**LOTS 1775 RP, 1785 RP, 1786, 1787 S.B, 1787, 1790 RP IN D.D 107
AND LOTS 21(PART), 22(PART), 28(PART) IN DD109
FUNG KAT HENUNG KAM TIN, YUEN LONG
(Application No. A/YL-KTN/1044)**

DRAINAGE IMPACT ASSESSMENT

Response to Comment Table Based on Comments in
Dec 2025 Report

RESPONSE TO COMMENTS for LandsD's Letter dated 9 April 2026

EXISTING CONDITION OF THE APPLICATION SITE

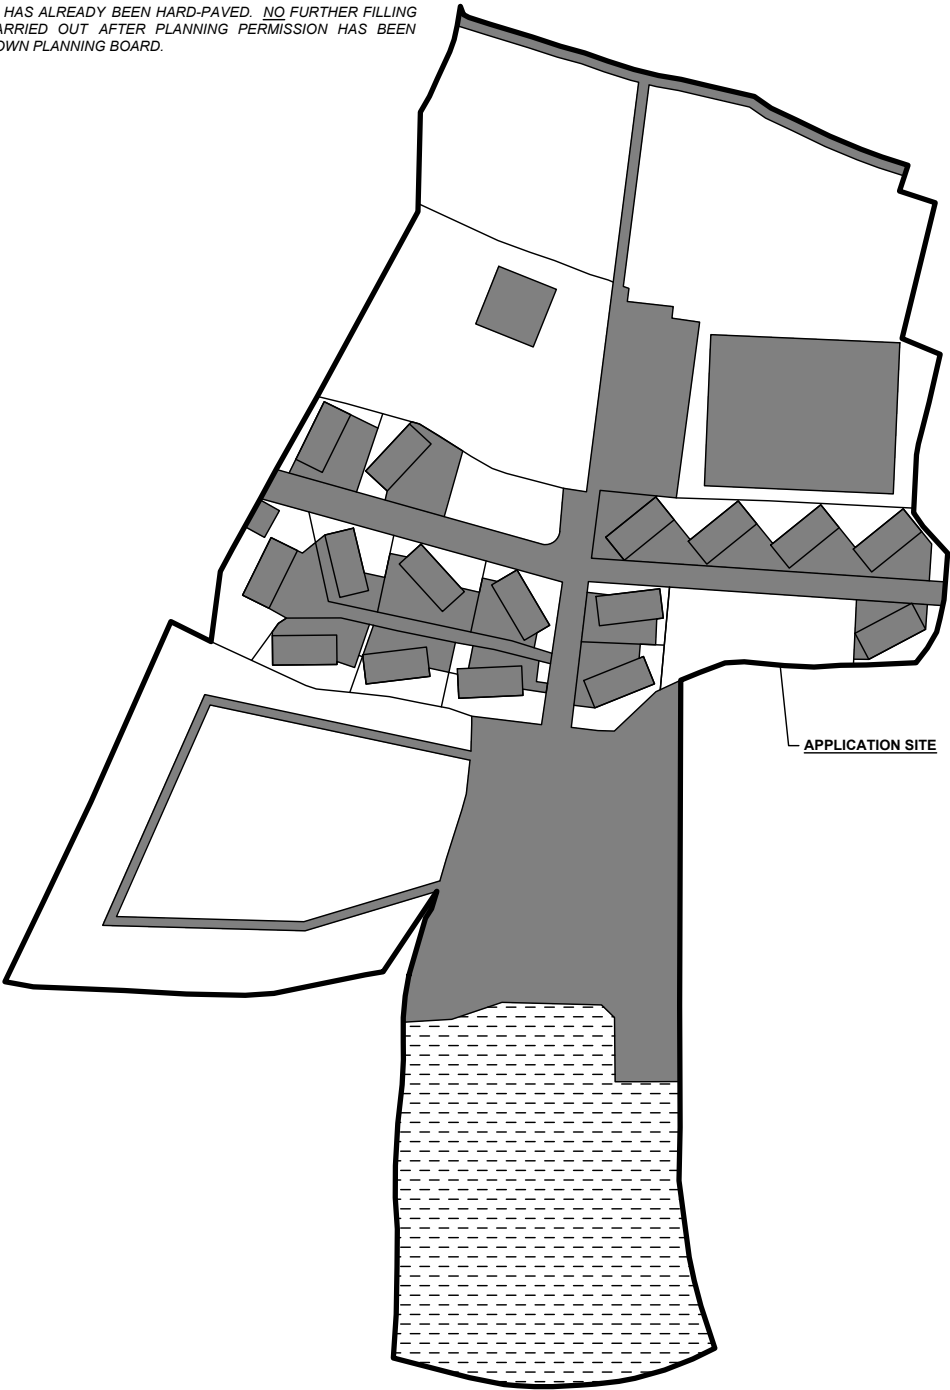
DSD/LD Comment	Response to DSD/LD Comments
(A) Specific Comments	
1 The applicant should indicate the proposed and existing ground levels of the application site and ground levels of adjacent areas on the drainage plan.	Noted. The proposed level, existing ground level and ground levels of adjacent areas are shown in the drainage plan.
2 Peripheral surface channels shall be provided along the site boundary to collect the surface runoff accrued on the application site and to intercept the overland flow from the adjacent lands. It is noted that there is proposed land filling works for the development. Proper surface channels should be provided at the lower level / platform and wall toe to collect the overland flow to/from adjacent areas	Noted. The peripheral surface channel is proposed at the East and South of the Application Site. The adjacent ground at the North and West of the Application Site are incline outward, hence, no peripheral surface channel is proposed. It is confirmed that no land filling works will be carried out.

THE APPLICATION SITE HAS ALREADY BEEN HARD-PAVED. NO FURTHER FILLING OF LAND WILL BE CARRIED OUT AFTER PLANNING PERMISSION HAS BEEN GRANTED FROM THE TOWN PLANNING BOARD.
